# UNITED STATES PATENT AND TRADEMARK OFFICE

APPLICATION NO.	FILING DATE	FIRST NAMED INVENTOR	ATTORNEY DOCKET NO.	CONFIRMATION NO.
10/747,875	12/29/2003	David Horsley	ONX-113/DIV	2815
27652	7590	01/11/2005	EXAMINER	
JOSHUA D. ISENBERG 204 CASTRO LANE FREMONT, CA 94539			WILLIAMS, HOWARD L	
			ART UNIT	PAPER NUMBER
			2819

## Office Action Summary

**FIG. 24**

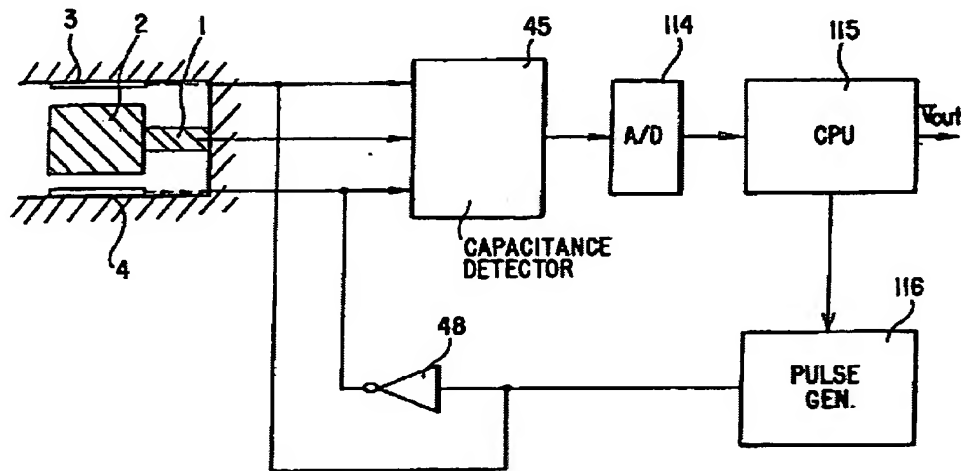
Claims 1-15 are rejected under 35 U.S.C. 102(b) as anticipated by Suzuki et al. (US 5,095,750). Suzuki et al. discloses a MEMs or electrostatic sensor/actuator which operates using pulse width modulation (PWM 47 cover) functioning in a servo loop. In figure 24

Suzuki shows the MEMs device (1-4), capacitance detection 45 shown in figure 21 to include an integrator, an analog-to-digital converter 114 and processor 115 for digital calculation of the desired duty cycle and pulse width modulation circuit 116. In column 9, lines 40-49 and again in column 12, lines 18-22 Suzuki et al. discloses that the frequency of the PWM signal should be greater than the natural frequency of the cantilevered movable electrode.
